4709 ROOSEVELT WAY NE

SDCI # 3038322-EG | MUP # 3036766-LU

RECOMMENDATION MEETING

01.30.2023

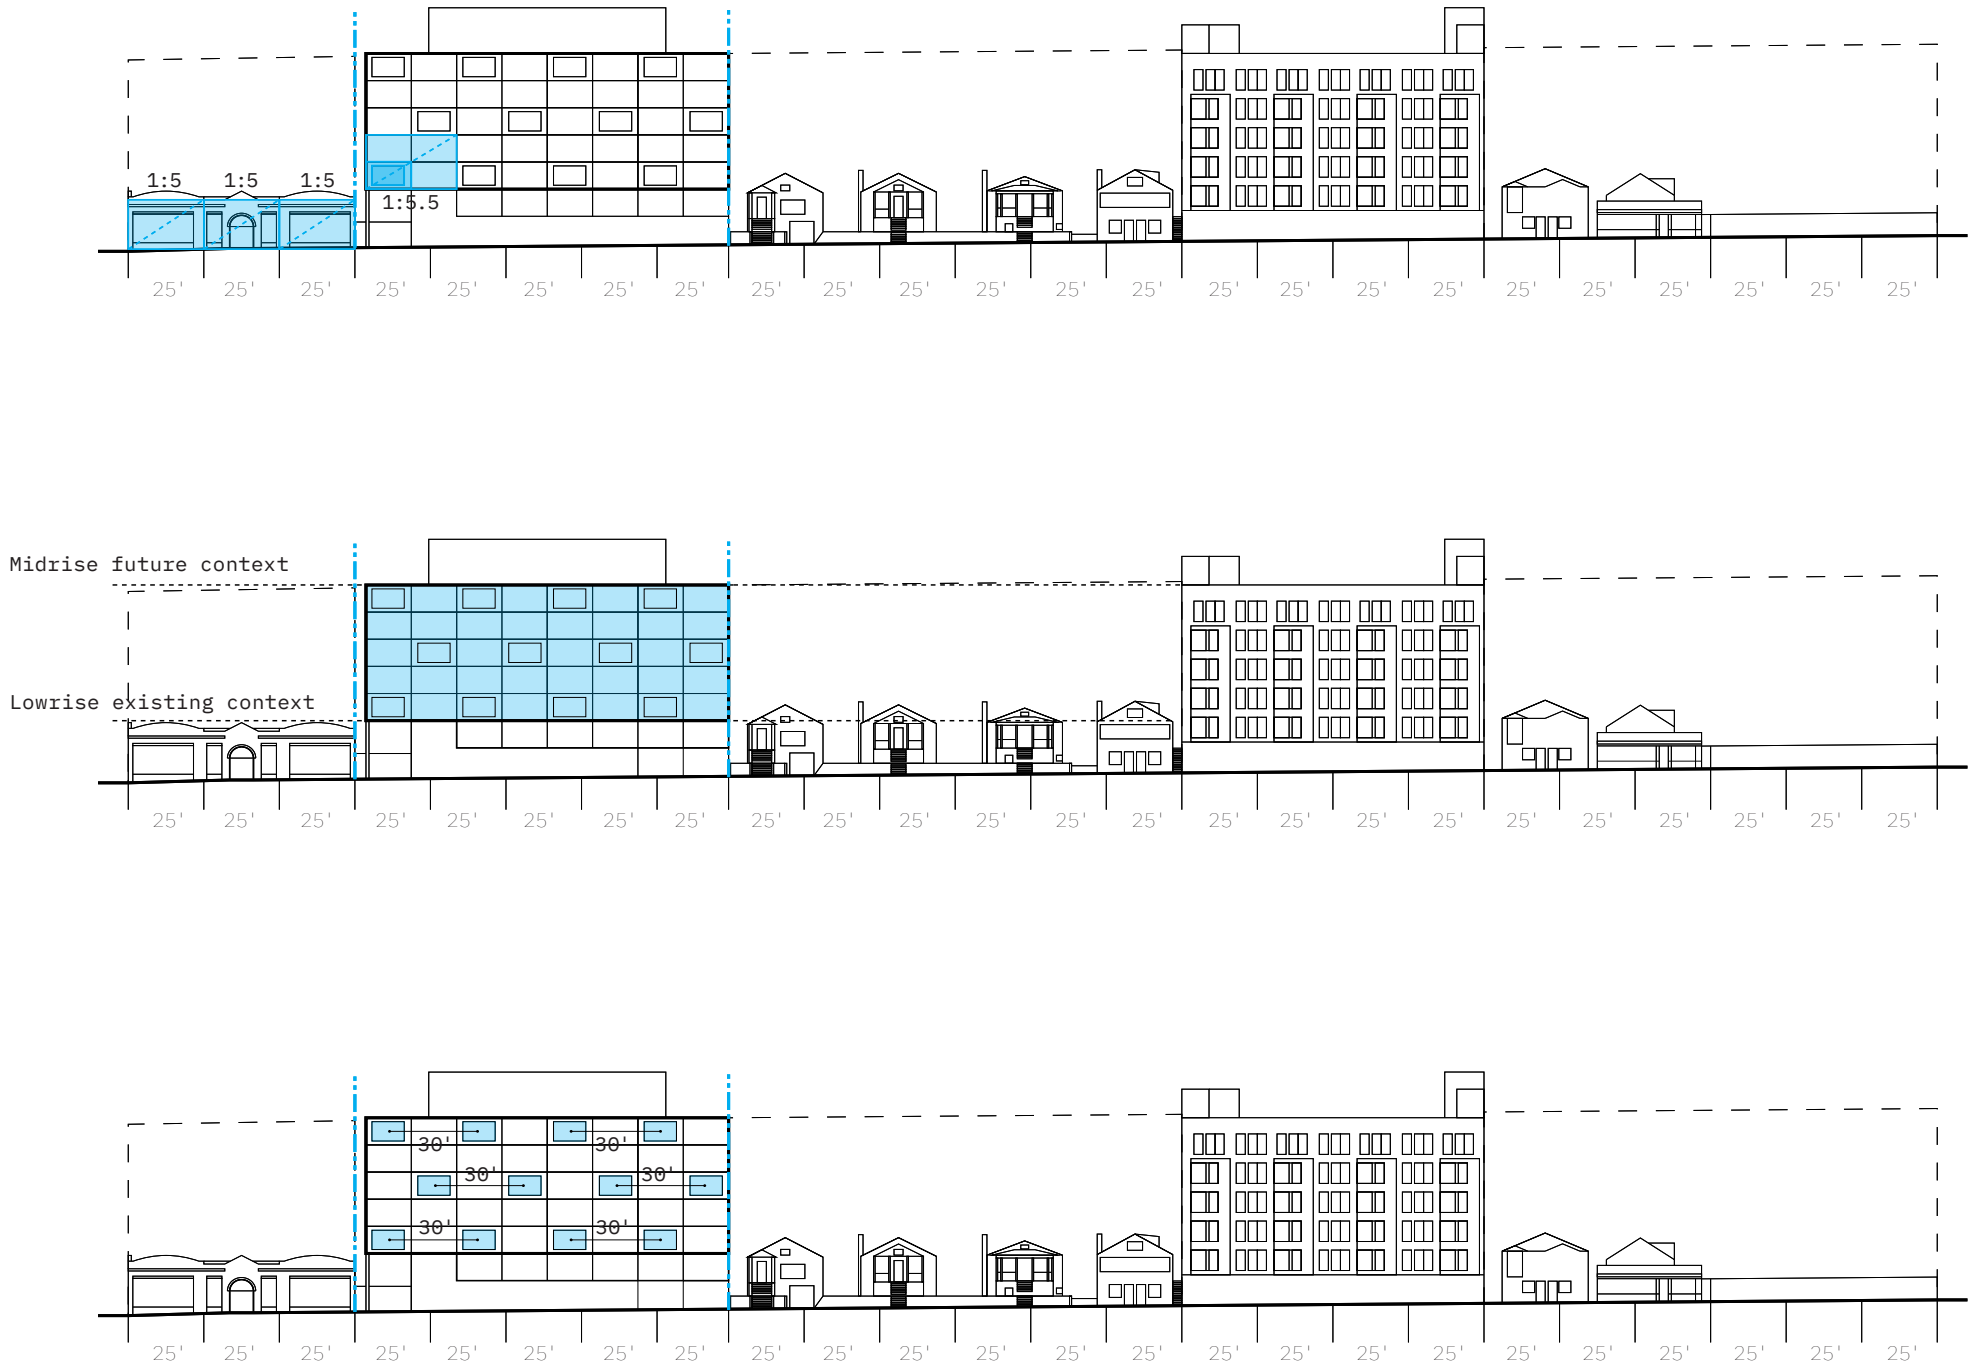
a. The Board supported the updated design stating that the new design vision included a clear context study and design process. The clarity of the design process assisted the Board in understanding how the design evolved. Board members stated the redesign of the building was very responsive to the guidance provided at the initial EDG meeting and the public comments. (CS2-B-1, CS2-C-2, University Supplemental Guidance – DC2-2-a)

Design Response:
The updated design vision supported by the board was maintained.
(Please see the appendix for EDG 2 "Message to the Board" for additional information regarding the updated design vision since EDG 1.)

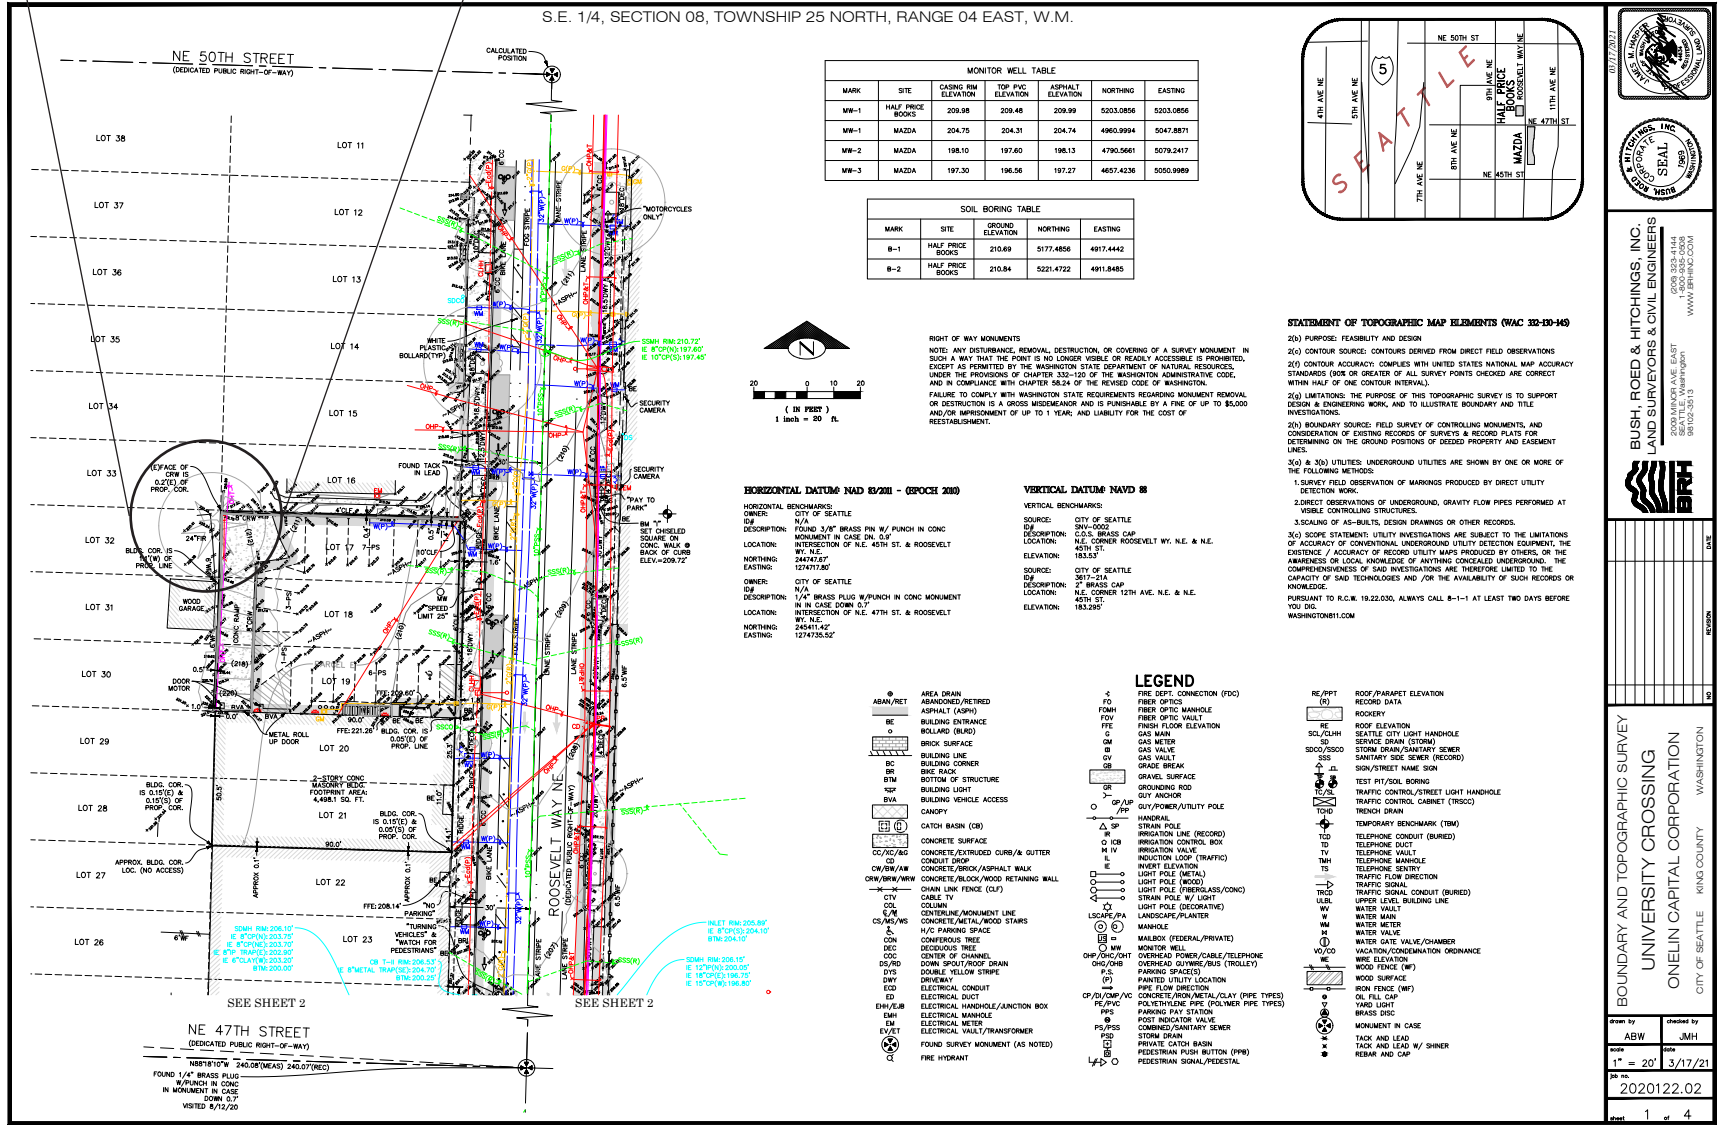
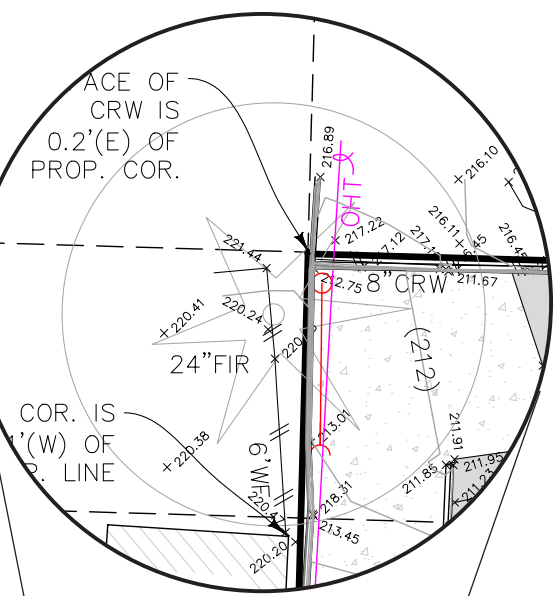
b. Board members supported the façade design noting that the analysis provided in the packet provided sufficient information to clearly understand how the façade design evolved from the initial EDG meeting. (University Supplemental Guidance – DC2-2-a)

Module of proposed apartment building on a 30' column bay further subdivided into 15' wide apartments; 15' x 9'-8" matches the proportions of the existing the 1.5 +/- ratio of the existing commercial building

A fenestration pattern of 9'-8" wide x 6'-6" high matches the proportions of the existing the 1.5 +/- ratio of the existing commercial building to express the existing platting patterns and proportions of its context.

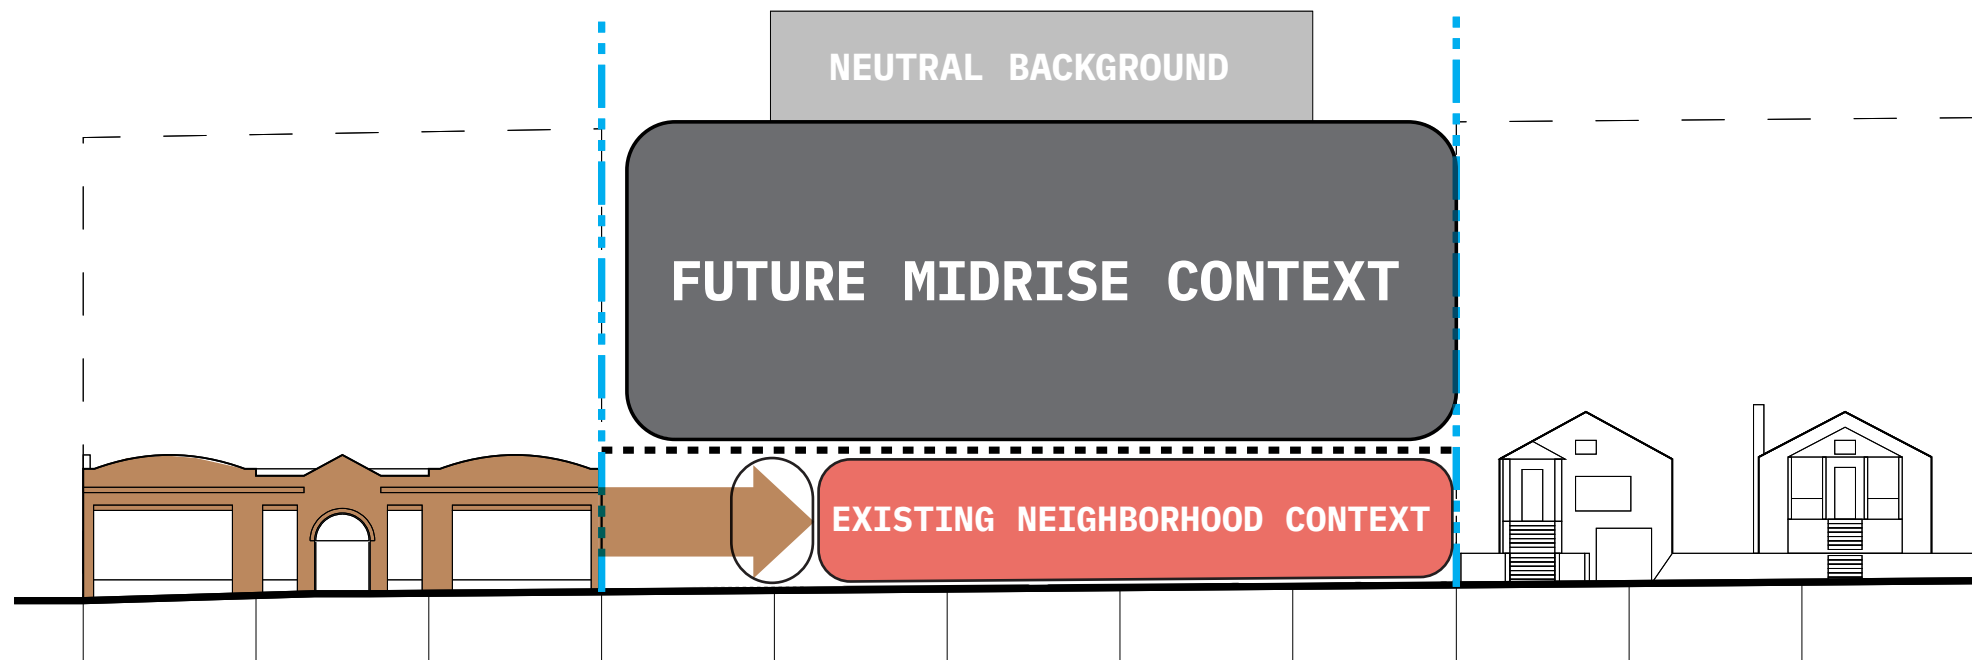
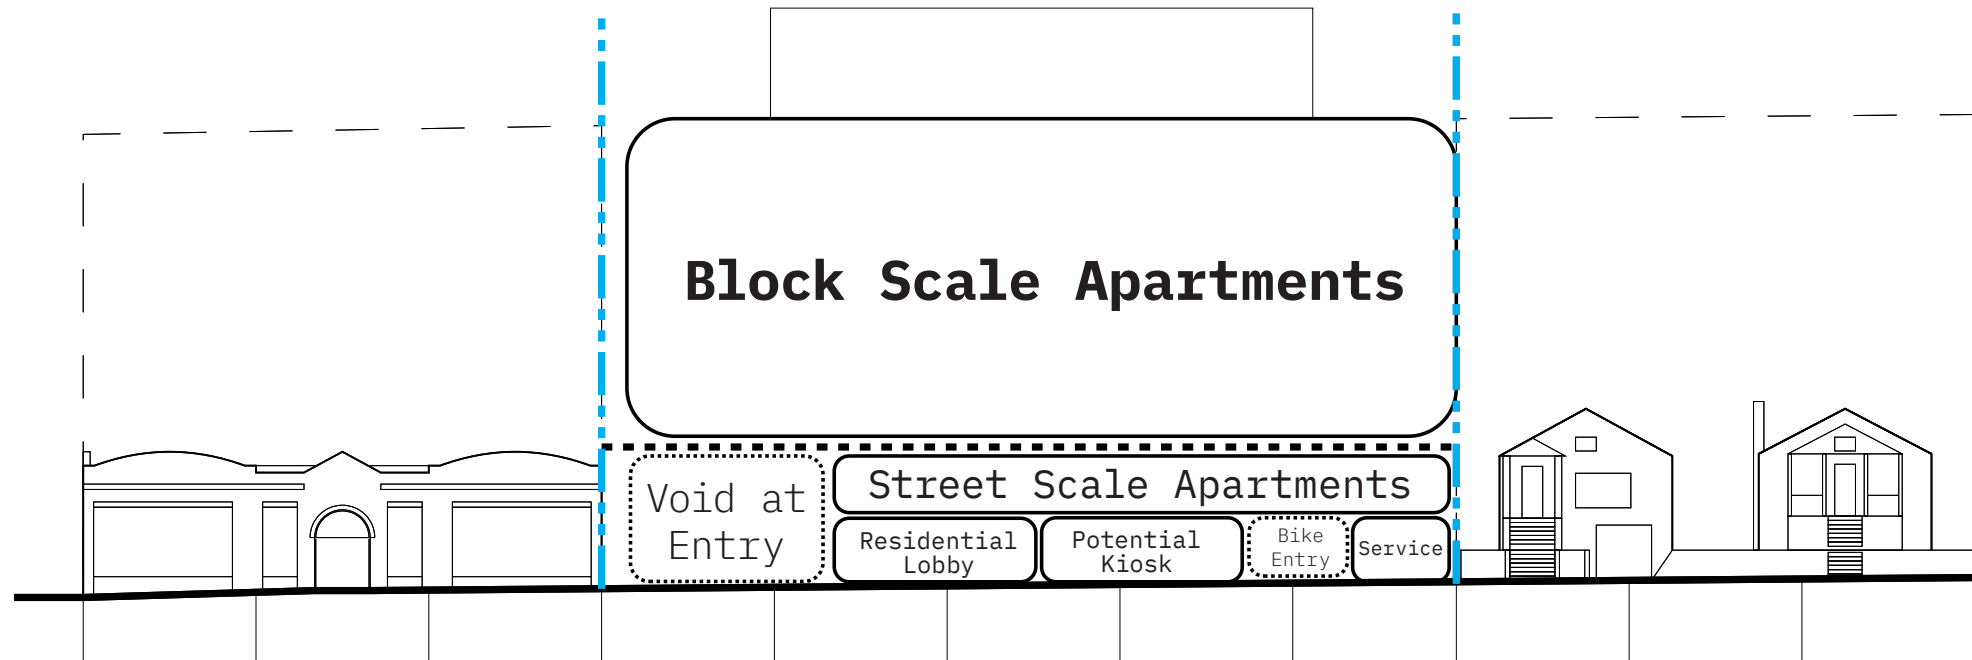
d. Board members questioned how the lower levels of the building relate to the context of the neighborhood. The Board requested the applicant further analyze how the street level spaces relate to the context of the neighborhood. While the Board supported the removal of the vehicle parking on the ground level, they requested the applicant explore how this could assist in creating more depth to the street level spaces, specifically how an expanded commercial space could be accommodated at the street level. (CS2-B-2, University Supplemental Guidance PL3-3-f)

The street level building elements above, the "Block Scale Apartments," reflects current zoning and intentions the city has for the block. It relates another mid-block structure to the north.

The lower diagram represents a color and material concept to strengthen the site pluralism proposed. A warmer palette below, at the pedestrian scale, a cooler block above anchoring the variety below and a light penthouse to minimize its visual impact seen at a distance.

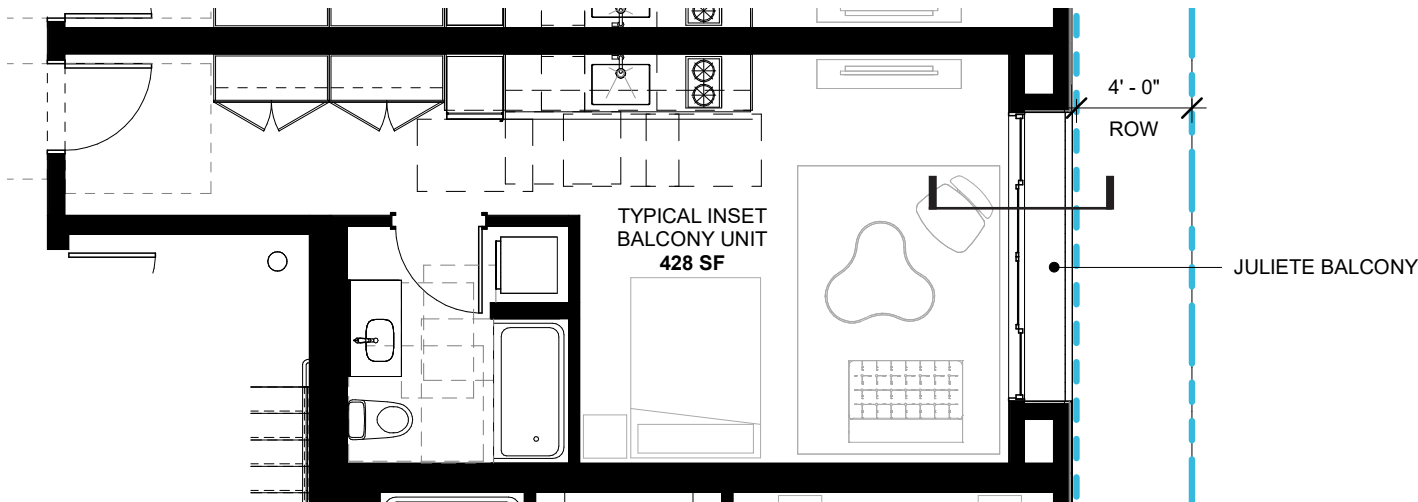
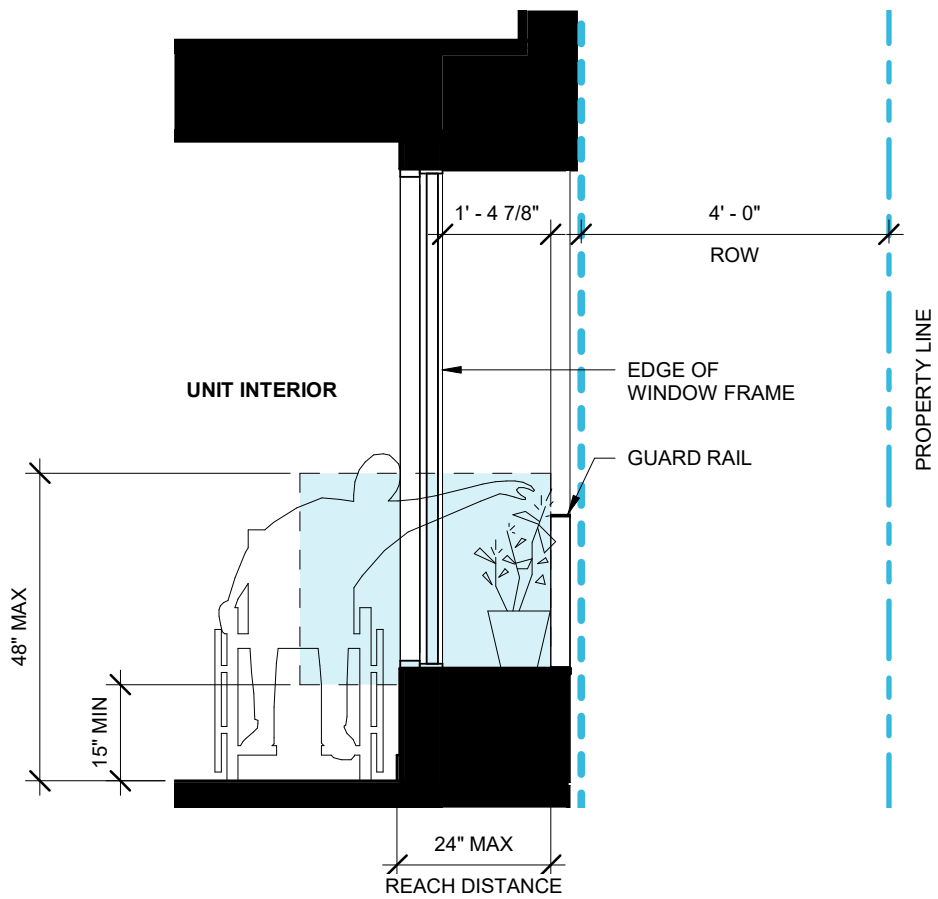
a. The Board found the new façade patterns appropriately tying into the context of the surrounding buildings. Board members noted the second level horizontal datum line's location made sense with the surrounding buildings. The double height entry off Roosevelt Way NE was supported by the Board along with the balconies on the east façade. While the Board supported the balconies facing Roosevelt Way NE, they found the narrow balconies do not provide the same level of use that a wider balcony would allow. The Board recommend the applicant explore ways to increase the balcony depth on the east façade and provide this information in the Recommendation packet. (University Supplemental Guidance – CS2-1-e, DC2-1-a)

The board supported facade concept and patterning remains. This includes the sill height of the street facing apartments. Since the apartments are compact, sills at the exterior window area provides for additional furniture arrangements and flexibility to the interior. The balconies proposed at EDG #2 are "Juliette style" and therefore not occupied. To make the balconies deeper, the compact apartments would have to be reduced or the balconies would be required to project beyond the facade. Projecting over the Street ROW or property line would trigger an annual Street Use permit and need to adhere to SMC 23.53.035 Structural Building Overhangs. SMC 23.53.035 which states: "structural building overhangs shall be removable per Title 15." and thereby not recommended or proposed by the applicant. The Juliette balcony depth were also designed with accessible reach ranges of 24" in mind.
